NO: PMS - 027	PRODUCT: EE-Series (Partial) – Photomicrosensors
DATE: February 2021	TYPE: DISCONTINUATION – Streamline Product Offering

EE-Series (Partial) Photomicrosensors – DISCONTINUATION

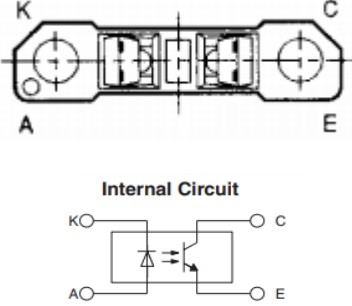
Differences from discontinued product:

Suggested Replacement Model	Body Color	Dimensions	Wire connection	Mounting Dimensions	Characteristics	Operation ratings	Operation methods
EE-SX1055	**	--	**	*	**	-	-
EE-SX1096	**	--	**	*	*	-	-

Discontinued Model	Suggested replacement
EE-SA103	EE-SX1055
EE-SA104	EE-SX1055
EE-SX1128	EE-SX1096
